Subject: **CAITHNESS BLYTHE II, LLC'S DATA RESPONSES SET 1  
BLYTHE ENERGY PROJECT PHASE II AMENDMENT  
DOCKET NO. (02-AFC-1C)**

# **BLYTHE ENERGY PROJECT PHASE II**

**(02-AFC-1C)**

**DATA RESPONSES SET 1**

**FIGURE 6-5**

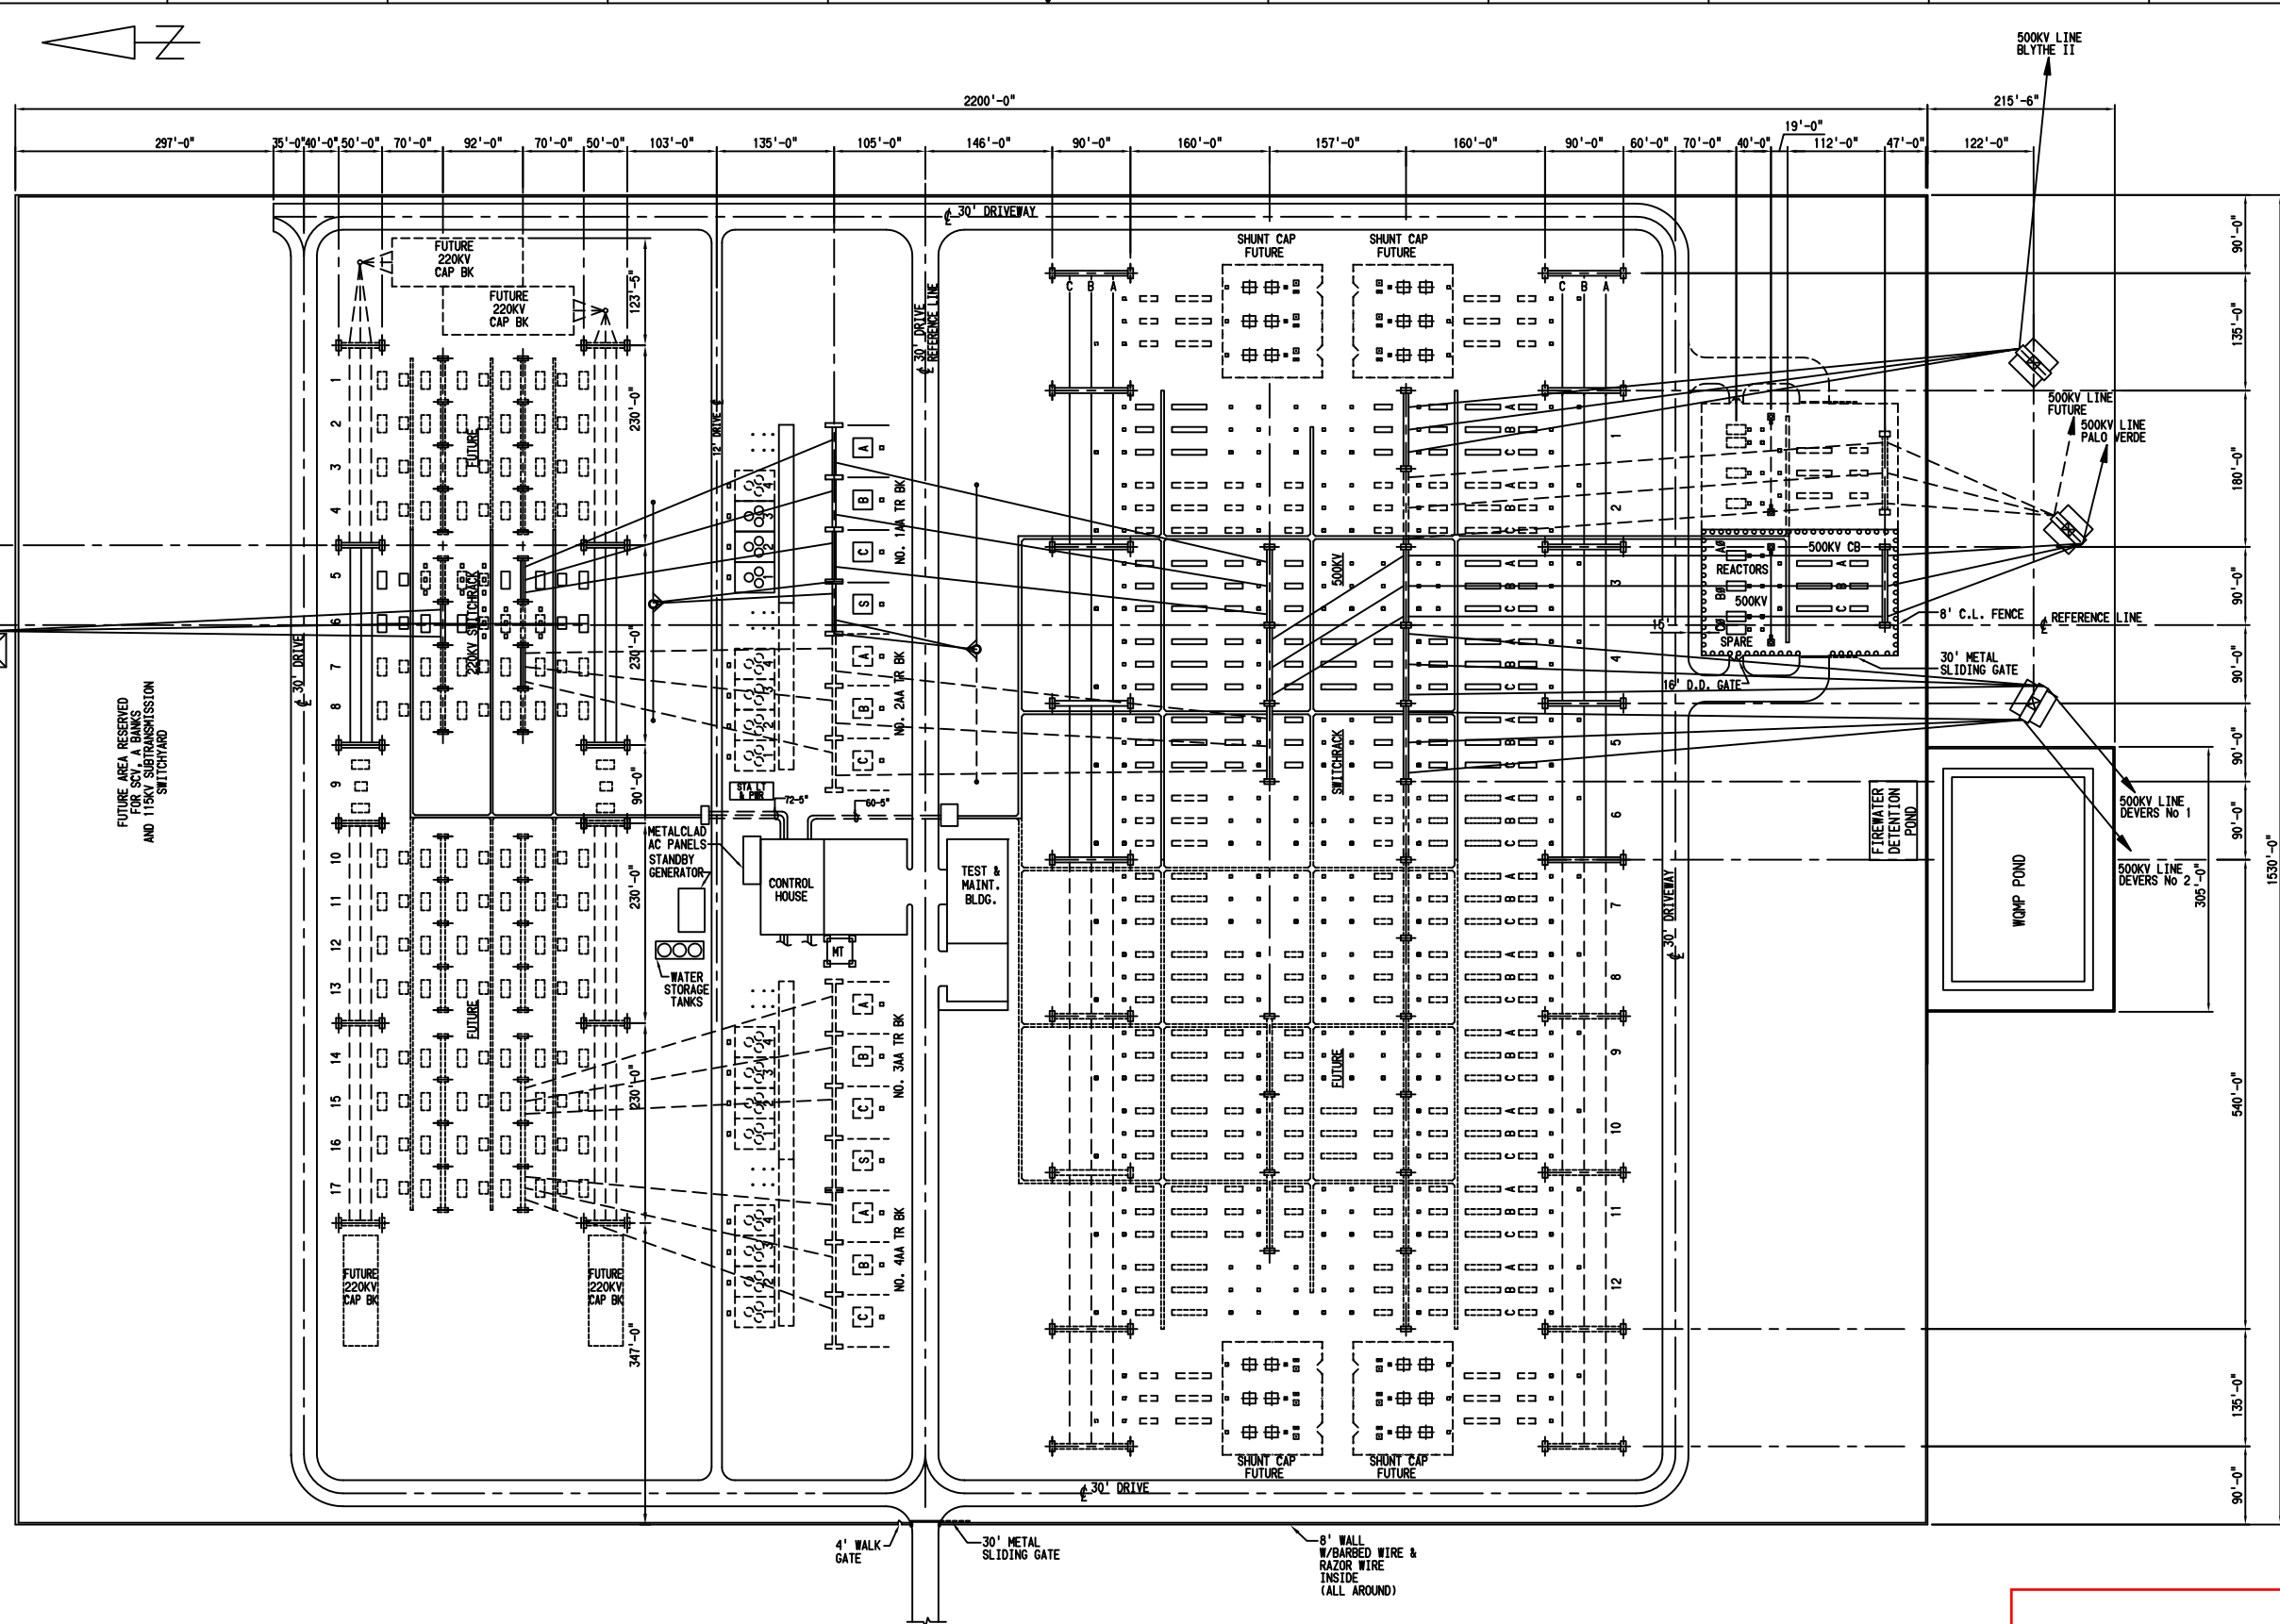
- 7. Please provide an electrical one-line diagram of the proposed new Colorado River 500 kV substation showing general arrangements of its buses, breakers, disconnect switches with specifics of the termination facilities of the proposed BEP II 500 kV generator tie line and their respective sizes and/or ratings in amperes.**

Please see the attached Data Response Set 1 Appendix. Attachment 7 in the Data Response Set 1 Appendix is Figure 6-5, an electrical one-line diagram of the permitted Colorado River substation.

**FIGURE 6-6**

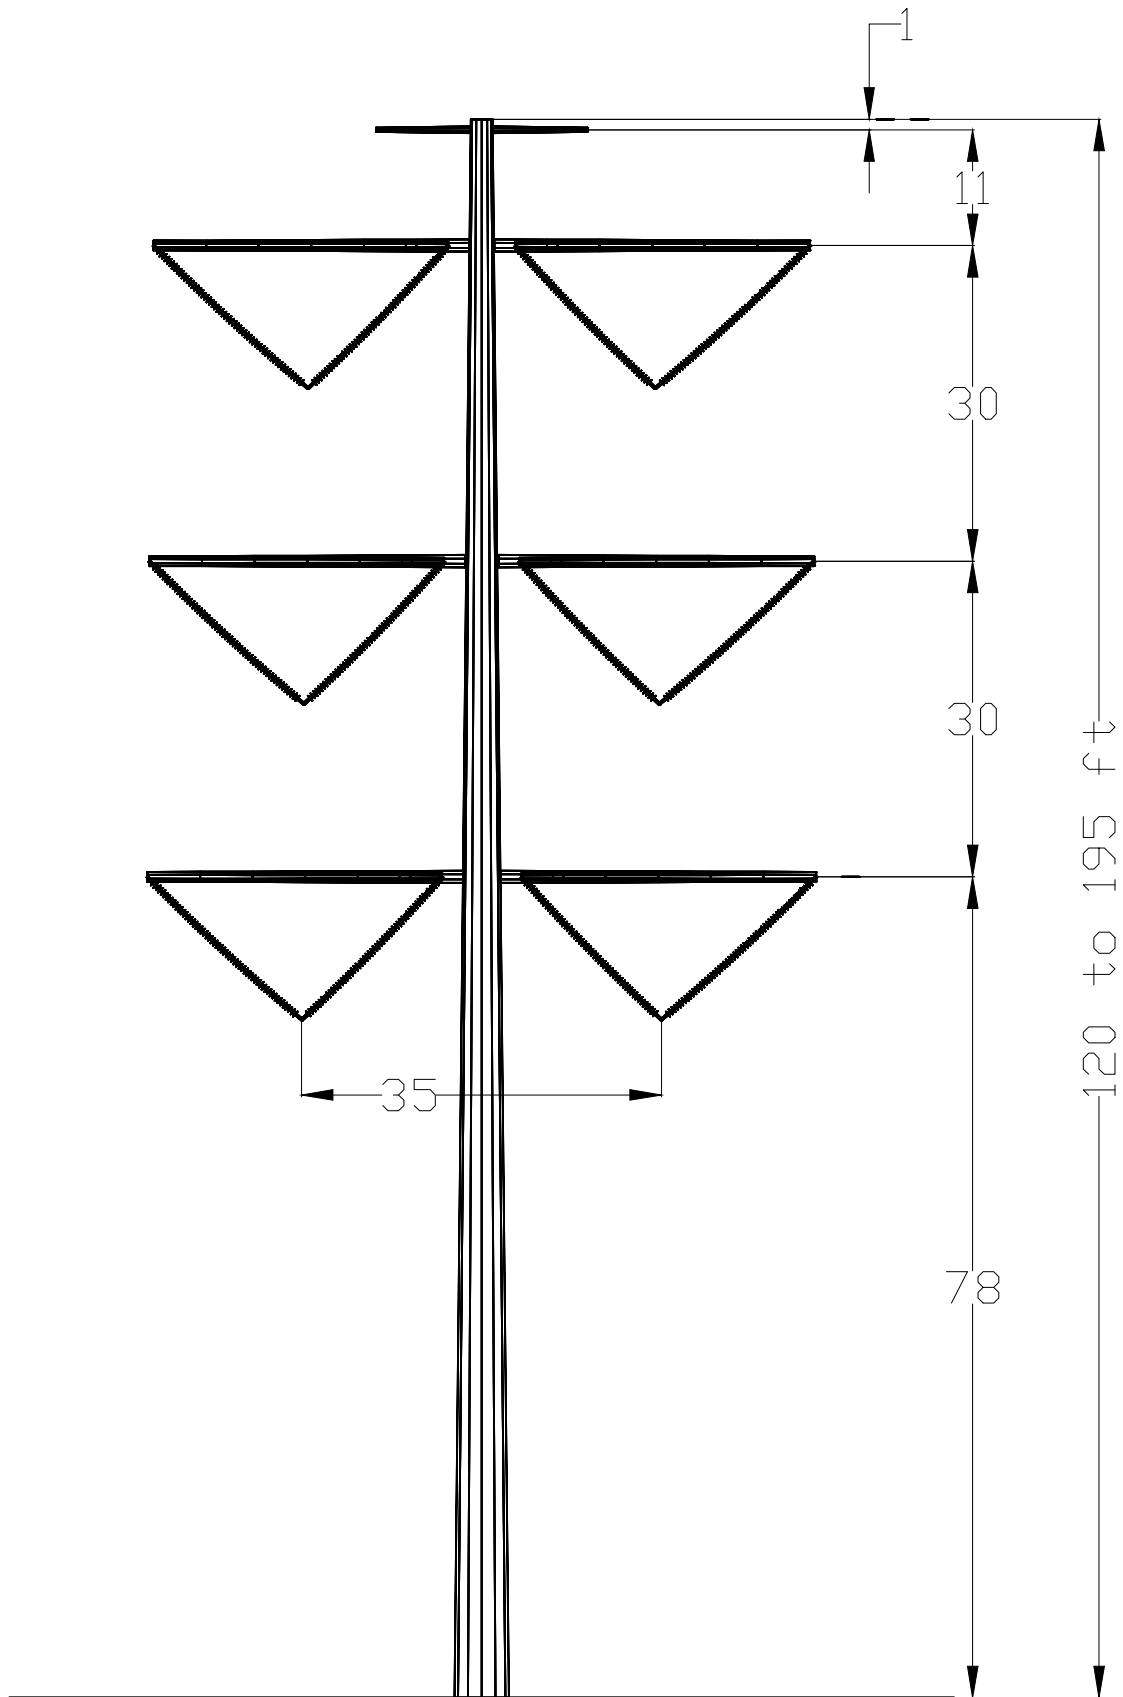
- 9. Please provide design diagrams for transmission steel lattice towers for the intermediate and dead-end structures showing the heights of the structure above and below ground, configuration of insulators and conductors (including ground conductors) with their respective position measurements on the structure.**

Please see the attached Data Response Set 1 Appendix. Attachment 6 in the Data Response Set 1 Appendix is Figure 6-6, design diagrams for transmission steel lattice towers from the permitted Keim substation to Colorado River substation. While the steel lattice towers in Figure 6-6 range in height from 120 to 195 feet, the steel lattice towers associated with the BEP II will each total 120 feet in height.
